# 2nd Gen Indoor Station Firmware

## V2.1.40\_build220428 Release Note

Device Model	DS-KH8350-WTE1、DS-KH8350-TE1、DS-KH6320-WTE1、DS-KH6320-WTE2、DS-KH6320-WTE2(B)、DS-KH6320-TE1、DS-KH8520-WTE1
Firmware Version	V2.1.40_build220428
iVMS-4200 Version	Latest version
Hik-Connect APP	Latest version

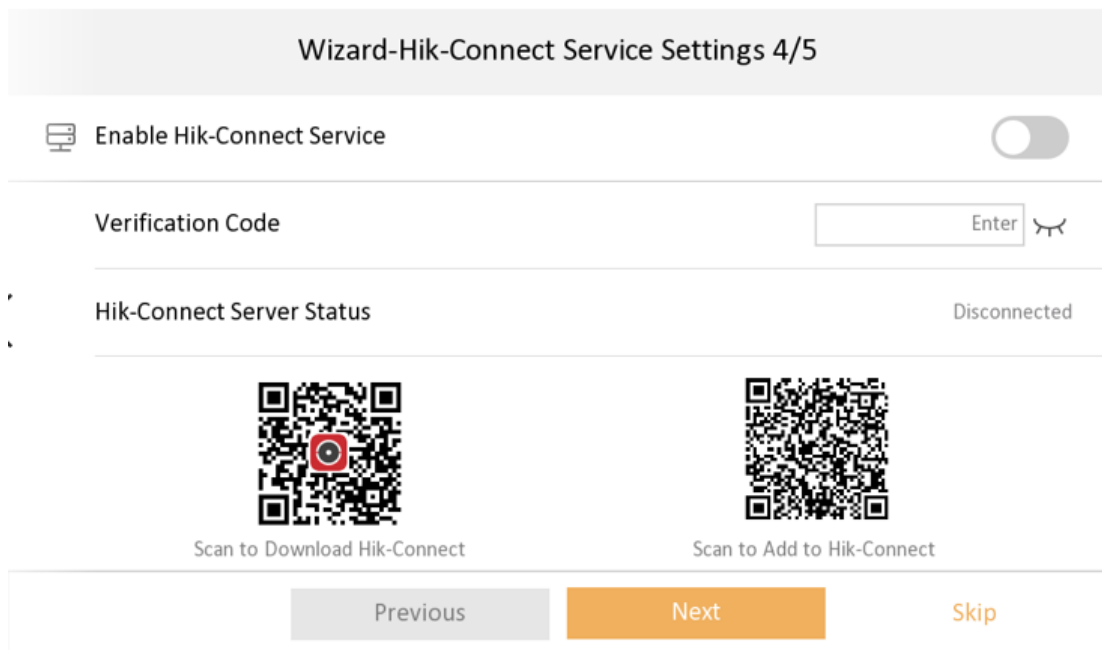
1. Optimize registration password settings in Wizard.

Registration Password Not configured. >  
 Be consistent with the activation password.  
When enabled, the people who has the registration password will have the device admin permissions.

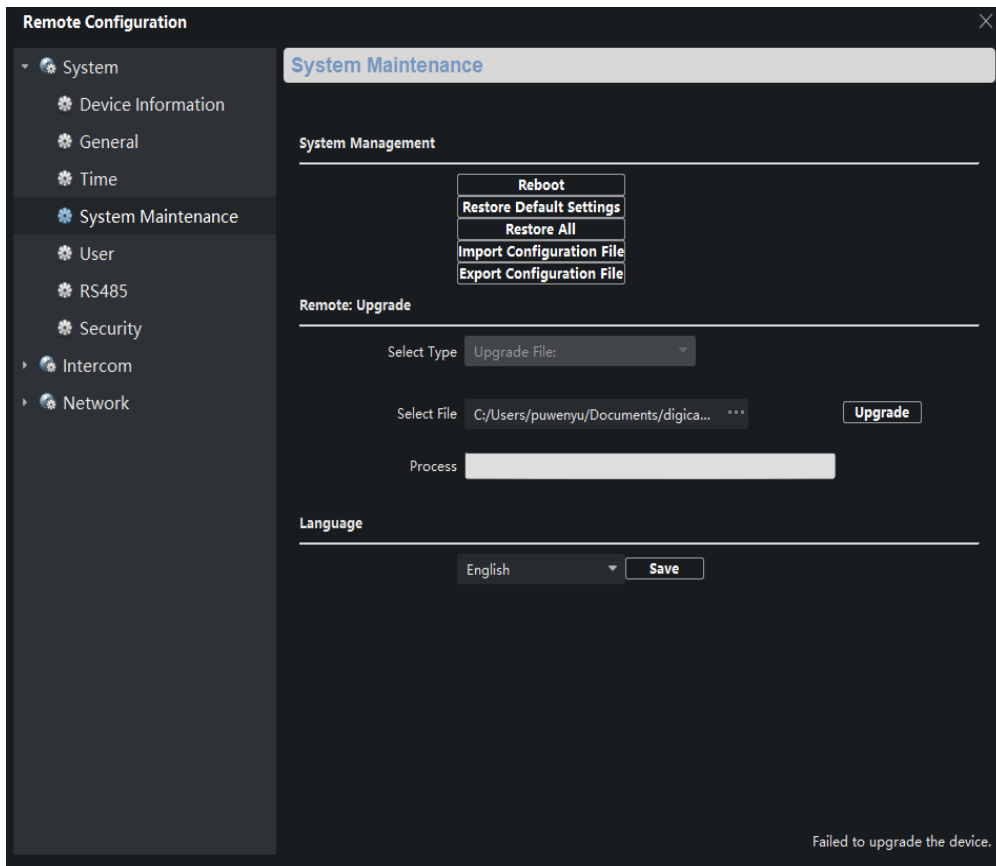
2. Hik-Connect Service Settings is changed to the place of Settings→ Advanced Settings→ Configuration→ System Maintenance.

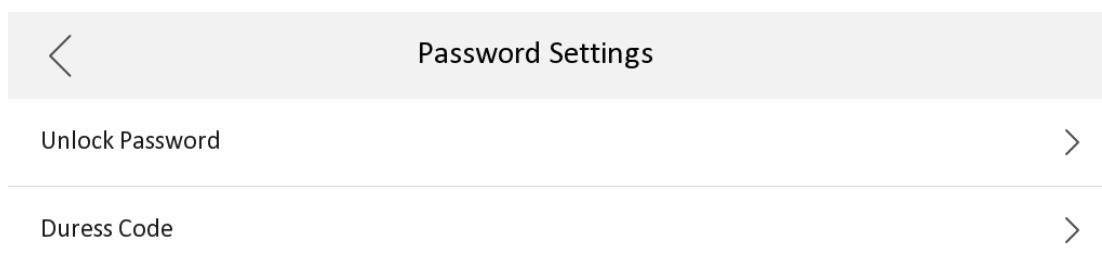
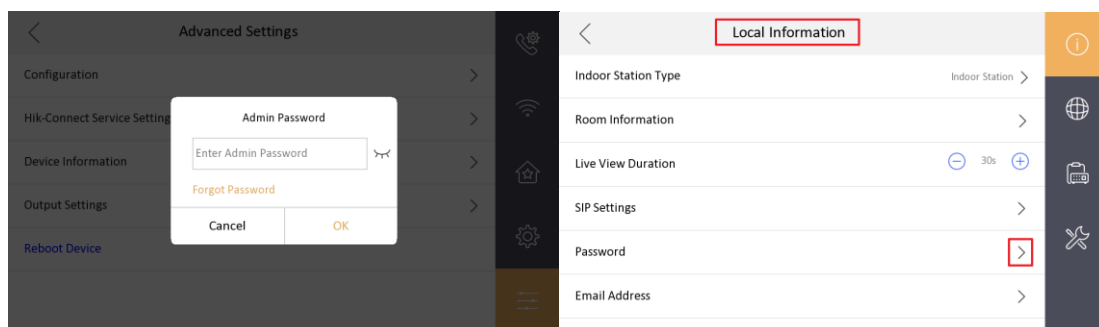
3. Newly added multi-language Croatian, Dutch, Romanian, Czech, Bulgarian, Croatian, Serbian
4. Add IPC interface, when Open Network Video Intercom protocol is selected, add plaintext ciphertext switch menu item configuration

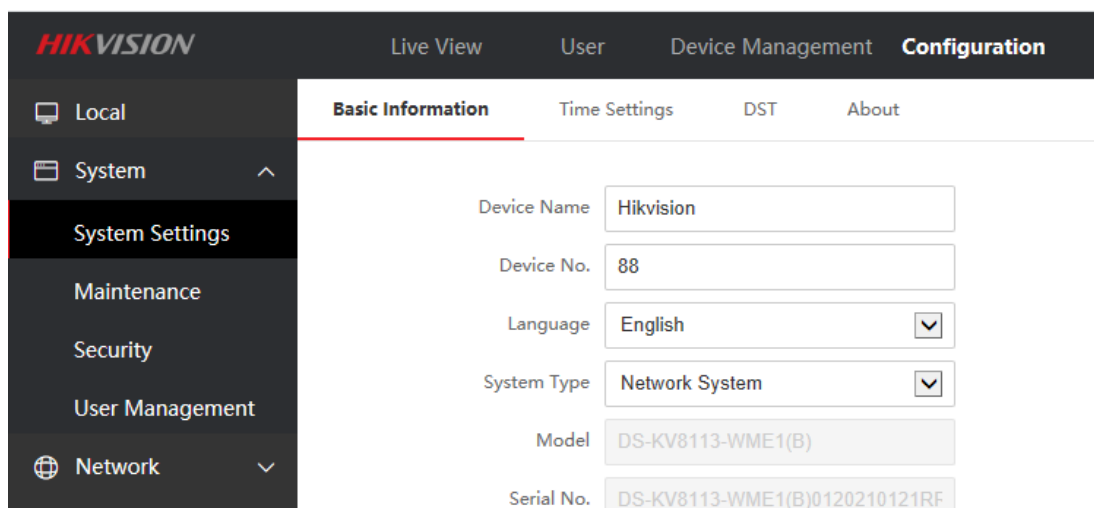
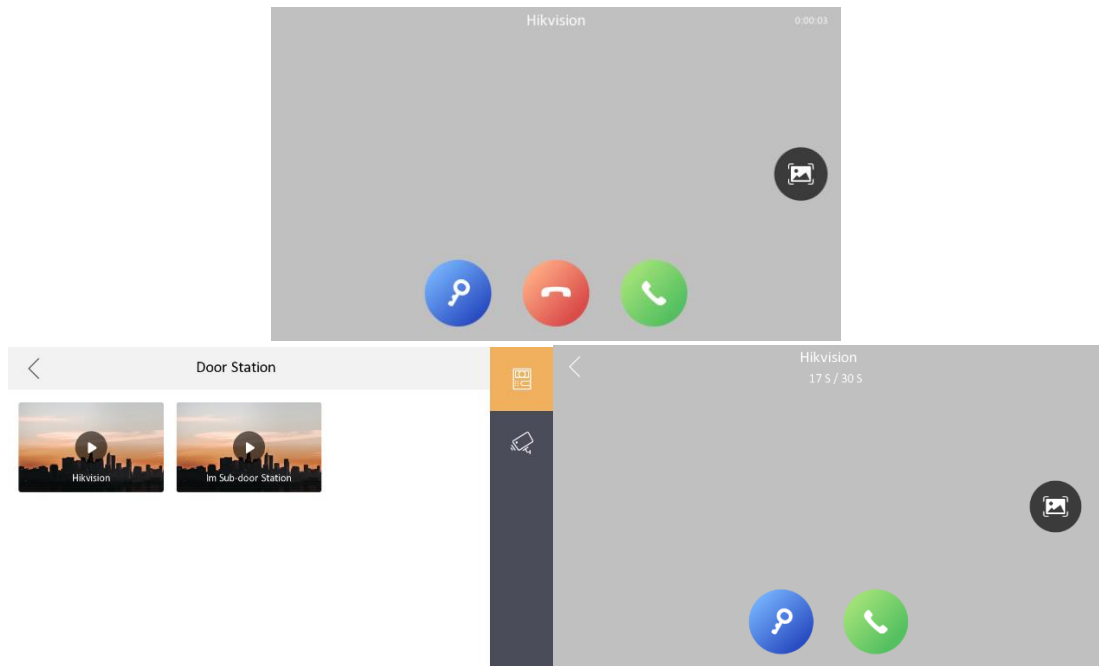
1. Change the position of unlock password and duress code, to enter the password page requires an admin (activation) password.

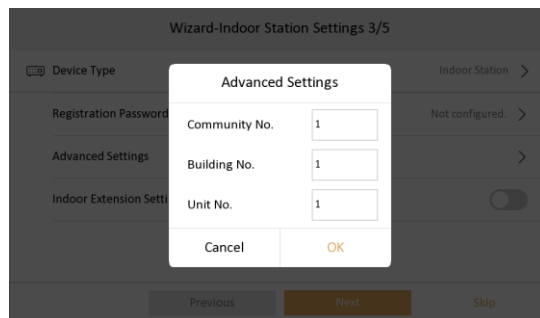
2. When changing the unlock password and duress code, the old password is not required as a credential.
3. The name of the local private SIP password configuration Sip Password is uniformly changed to Registration Password
4. The changed name of the door station(KD8003 modular door station, KV(-B), KB8113) will be displayed on the call interface or live view interface of the indoor station

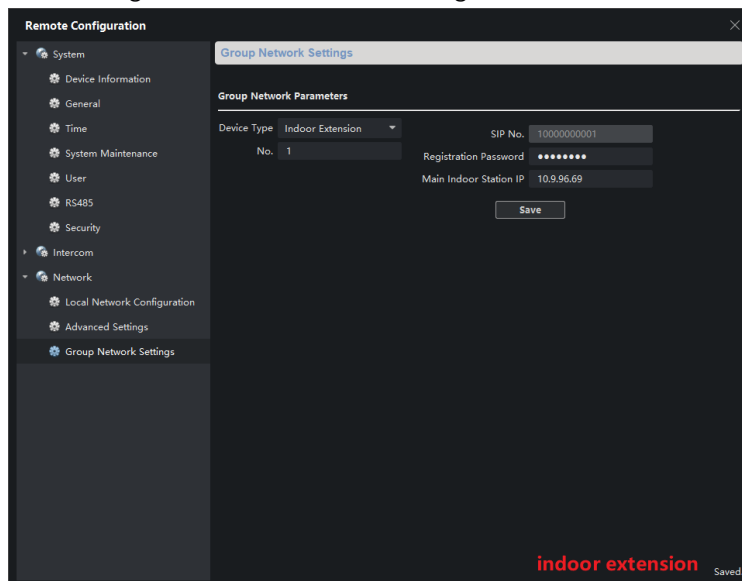
- The local interface community number, building number, and unit number of the indoor station will be stored in the advance column instead of being displayed directly

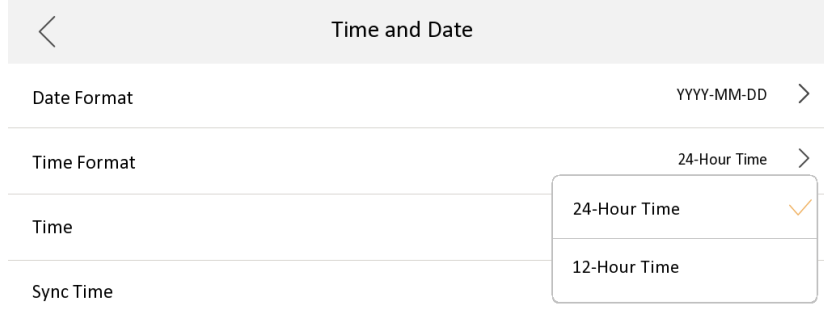
1) Support three formats in Settings->General Settings->Time and Date interface, set year-month-day, day-month-year, month- day - year

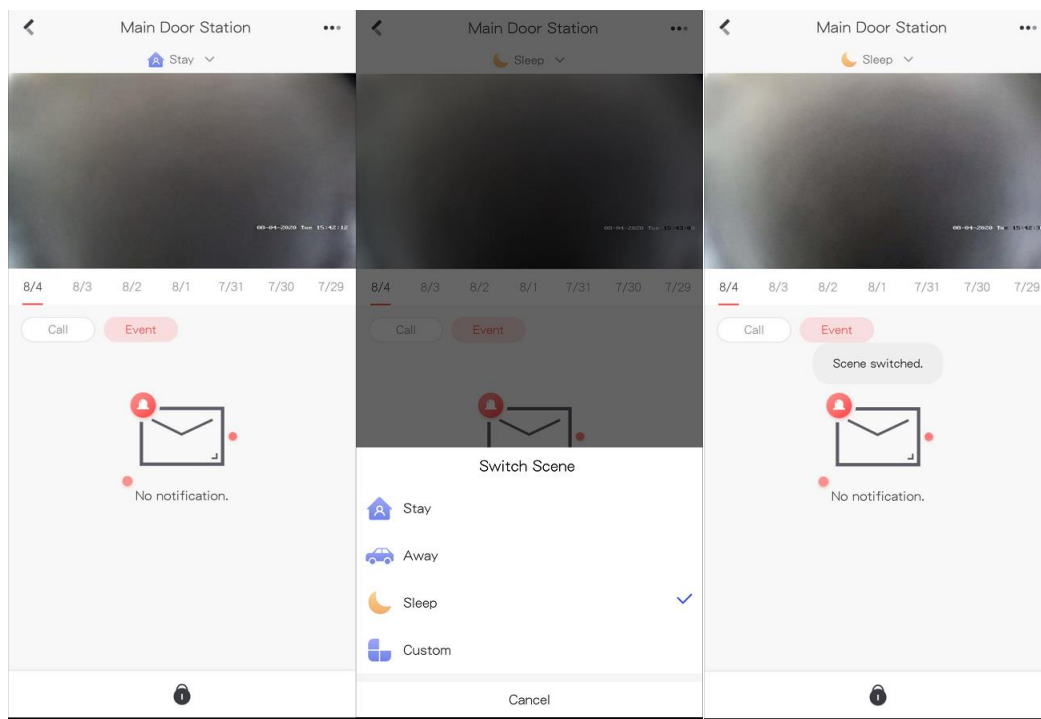
3. Multi-language added to 12 countries: English, French, Portuguese (Brazil), Spanish, Russian, German, Italian, Polish, Arabic, Turkish, Vietnamese, Ukrainian.

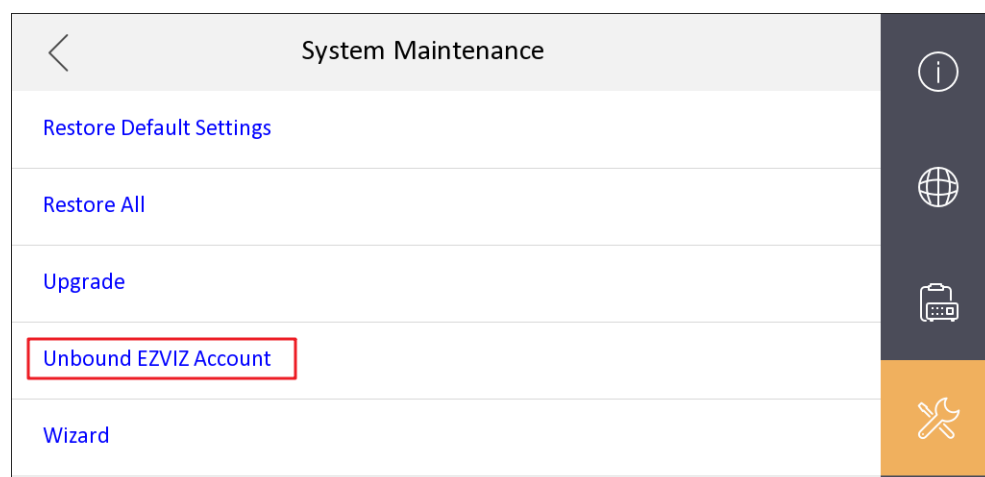
7. Add the QR code of Hik-Connect App download address to the indoor station Hik-Connect configuration interface

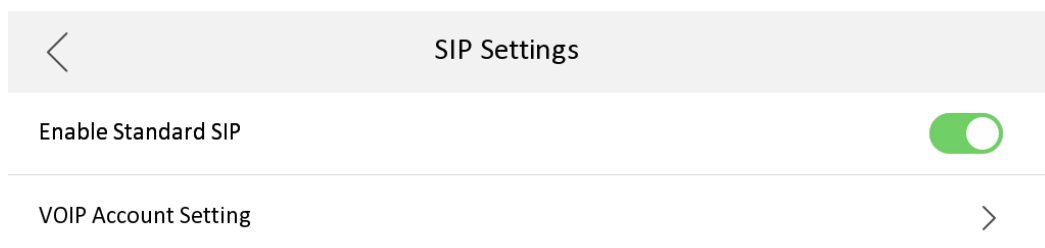
b) The standard SIP of the indoor station is disabled by default, if you want to connect to a third-party standard SIP device, you need to turn on this function.

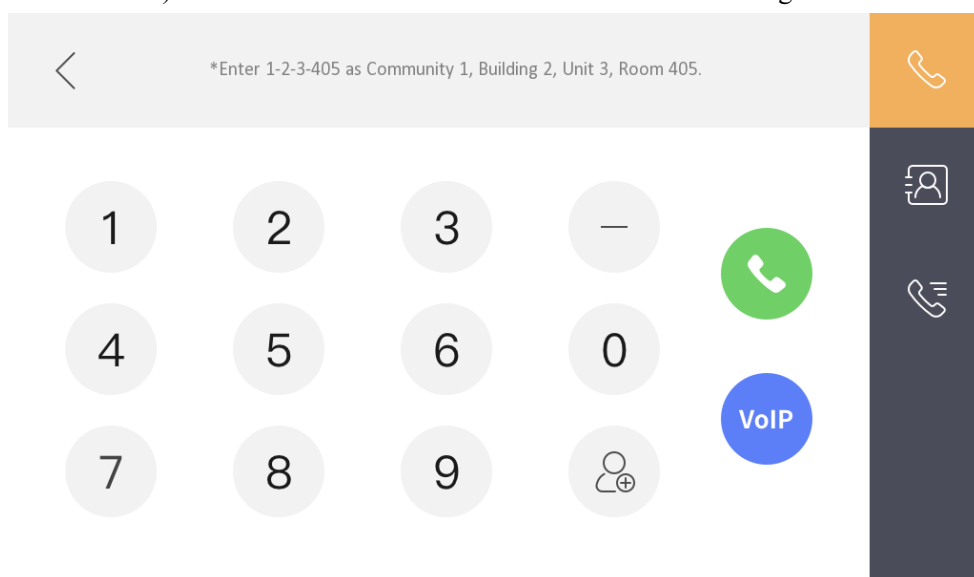
d) Added a VoIP call button in the call interface to distinguish standard SIP calls
